**ZONING AMENDMENT,**  
**PLANNED UNIT DEVELOPMENT &**  
**SUBDIVISION STAFF REPORT**

**Date: September 21, 2006**

<b><u>NAME</u></b>	O. A. Pesnell, Jr.
<b><u>SUBDIVISION NAME</u></b>	Brookview at Brookside Subdivision
<b><u>LOCATION</u></b>	North and East sides of Pesnell Court at its North terminus, extending to the West side of Inverness Subdivision, Unit Two.
<b><u>CITY COUNCIL DISTRICT</u></b>	District 6
<b><u>PRESENT ZONING</u></b>	R-1, Single-Family Residential and R-3, Multi-Family Residential
<b><u>PROPOSED ZONING</u></b>	R-3, Multi-Family Residential
<b><u>AREA OF PROPERTY</u></b>	18.0 ± Acres
<b><u>CONTEMPLATED USE</u></b>	<p>Rezoning from R-1, Single-Family Residential, and R-3, Multi-Family Residential, to R-3, Multi-Family Residential, to eliminate split zoning in a proposed one-lot residential subdivision and planned unit development, Planned Unit Development to allow 22 single-family residential dwellings on a single building site with private street access, and Subdivision of two parcels and two lots into one lot.</p> <p><b>It should be noted, however, that any use permitted in the proposed district would be allowed at this location if the zoning is changed. Furt

# SITE PLAN

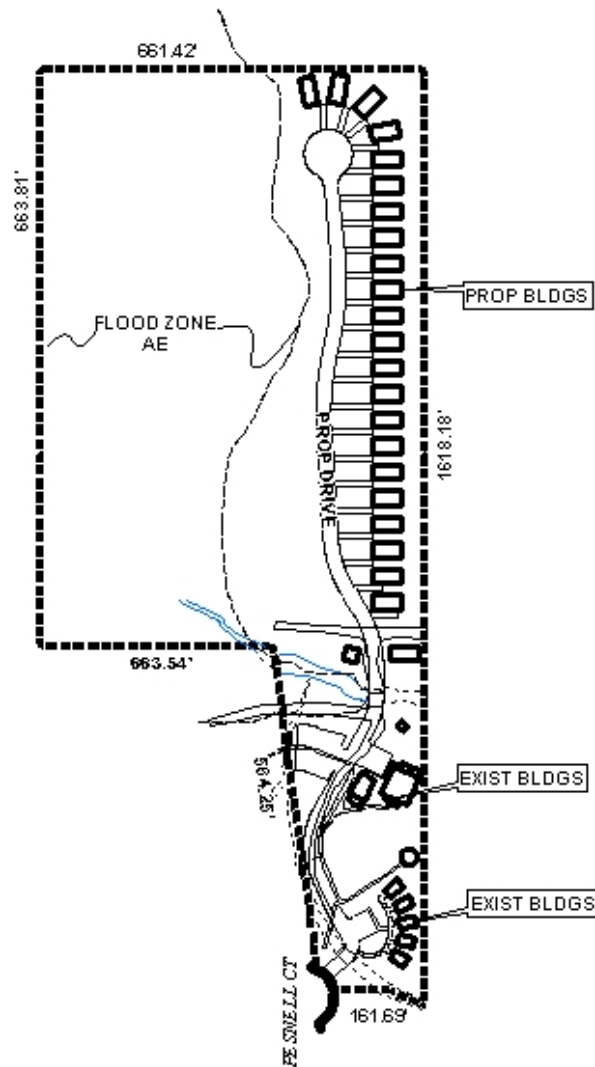
The site under review appears to contain extensive floodplains and wetlands associated with Milkhouse Creek. It is not clear if the site plan and plat accurately depict the limits of the existing floodplains and wetlands, especially when compared to the 2003 application. Staff is not able to determine if the proposed development would impact these natural features, thus the site plan and plat should be revised to accurately depict these features.

The proposed private road will be approximately 1600 feet long, from where it starts at Pesnell Court to its cul-de-sac termination. As Pesnell Court is itself a cul-de-sac off of Cottage Hill Road, the proposed design will result in a development with extremely limited access. The private road will also have a nearly ninety degree turn near where it intersects Pesnell Court; this proposed turn should be modified to so that the curvature of the private road meets minimum Traffic Engineering and AASHTO requirements. Furthermore, full compliance with Fire Department regulations will be required in order to ensure the safety of future residents.

Due to the extent of the proposed development, full compliance with the City’s stormwater regulations will be required. As PUD approval is site plan specific, and as a stormwater detention basin will likely be required, the applicant should consult with the Engineering Department and revise the site plan as necessary to depict any required stormwater detention.

There is no indication on the site plan as to the proposed location of any dumpster or other waste storage facility. The location of the storage area for the dumpster must be indicated on the site plan, and the location and required screening must comply Section 64-4.D.9. of the Zoning Ordinance, as well as with all other applicable regulations.

It also appears that one of the proposed homes encroaches upon the required setback along the North property line. The site plan should be revised to ensure that all structures meet setback requirements delineated in the Zoning Ordinance, and that appropriate adjacency buffers are depicted.

**Planned Unit Development:** The PUD request is recommended for Holdover until October 19<sup>th</sup>, with revisions due to Urban Development by October 3<sup>rd</sup>, to give the applicant time to address the following: 1) revision of the legal description for all applications (zoning, PUD, subdivision) to include Lot 3 of the Pesnell Subdivision; 2) revision of the site plan and subdivision plat to comply with Engineering comments listed at the beginning of the staff report, including the accurate depiction of all floodplain and wetland areas and drainage easements on the site plan and plat; 3) revision of the private street to provide a more direct linkage to Pesnell Court, and provision of a turn-around at the midpoint of the private street, as well as at the terminus; 4) consultation with Fire / Rescue to determine modifications to the private street or site plan necessary to comply with their regulations, and revision of the site plan as appropriate; 5) revision of the site plan to depict compliance with the open space and tree and landscaping requirements of the Zoning Ordinance, including the necessary site calculations required by Section 64-5.C.2. of the Zoning Ordinance; 6) depiction and labeling of any required stormwater detention basins; 7) depiction and labeling of dumpster locations, with screening that complies with Section 64-4.D.9. of the Zoning Ordinance; 8) revision of the site plan to ensure that all proposed structures meet setback requirements; 9) provision and depiction of a 10-foot wide vegetative buffer and 6 to 8 foot high privacy fence or wall where the portion of the site to be developed abuts adjacent R-1 districts; 10) placement of a note on the site plan stating that maintenance of all common areas, private streets, and detention areas is the responsibility of the property owners; and 11) placement of a note on the site plan stating that lighting shall be so arranged that the source of light does not shine directly into adjacent residential properties or into traffic, per the requirements of Section 64-4.A.2. the Zoning Ordinance.

**Subdivision:** The Subdivision request is recommended for Holdover until the October 19<sup>th</sup> meeting to accommodate the PUD revisions, and the following requirements: 1) revision of the plat to accurately depict all floodplain and wetland areas and drainage easements, per Engineering Comments; and 2) revision of the legal description to include Lot 3 of the Pesnell Subdivision.
